TO: Planning Commission Members

FROM: Andrea Campisi, Senior Planner, Building and Planning Department

SUBJECT: TENTATIVE SKETCH PLAN – 1800 W. Montgomery Avenue & 1835 County Line Road, Lower Merion School District Athletic Fields, Villanova, LD# 3833, Ward 6

DATE: September 6, 2019

2. Overall Site Design

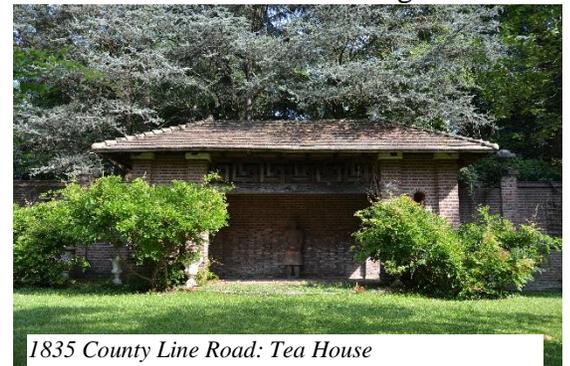
Evaluating the impacts to natural features and the surrounding neighborhood are key components of the Tentative Sketch Plan phase. Another primary focus of the Tentative Sketch Plan review should be setting up a program for the Preliminary Plan to ensure that the edges of the property are designed to mitigate off-site externalities on the surrounding neighborhood through landscaping and fencing. The landscaped edges of the property should be designed as a naturalized ecosystem.

Given the fact that the property contains many large trees, wetlands and historically significant elements, the applicant must pay extra attention to minimizing impacts to these features. In addition, provisions for potential future expansions to integrate the campus with the nearby middle school site should be considered. In furtherance of that, the applicant submitted a pedestrian connectivity study with the Preliminary Plan application for the middle school. Specific recommendations related to the site design are included below.

- **Alternative Site Layouts to Enhance Open Space and Preserve Historic Elements**

While none of the buildings or elements on 1800 W. Montgomery Avenue are on the Historic Resource Inventory, they are nonetheless historically significant and warrant protection. Members of Township staff, the Lower Merion Conservancy and the Historical Commission have been working to devise alternative layouts for the fields that would preserve some of the historically significant elements on 1800 W. Montgomery Avenue including the former brick greenhouse related structures and the walls that connect them.

In addition, while the main house on 1835 County Line Road is being preserved, the tea house, which is a small brick open roofed structure surrounded by garden walls, is shown to be

removed. Since the building itself is not in the way of the baseball field, it may be possible to preserve it. Staff has included this as a condition of approval.

The applicant proposes to provide bus access into the site from Stone Ridge Lane, which currently dead ends into 1835 County Line Road. Currently there is no vehicular access from Stone Ridge Lane into the site. Although the applicant indicates that a small number of buses will visit the site on a daily basis, those buses will have to travel through the adjoining residential neighborhood. In order to minimize disturbances to the neighborhood, staff and the Township Engineer recommend the applicant revise the site layout to eliminate vehicular access from Stone Ridge Lane. Eliminating the vehicular entrance from Stone Ridge Lane would also require a bus turnaround that, per the Fire Marshall, would also be necessary for fire trucks and other emergency vehicles that may need to access the site.

The Zoning Officer has reviewed the proposed parking count and determined that since the use of the existing house and pool house to remain has yet to be determined, the final parking count can not be calculated.

Staff, including the Township Engineer, supports the Montgomery County Planning Commission's recommendation to connect the two proposed surface parking lots to eliminate the dead end nature of the lots as proposed.
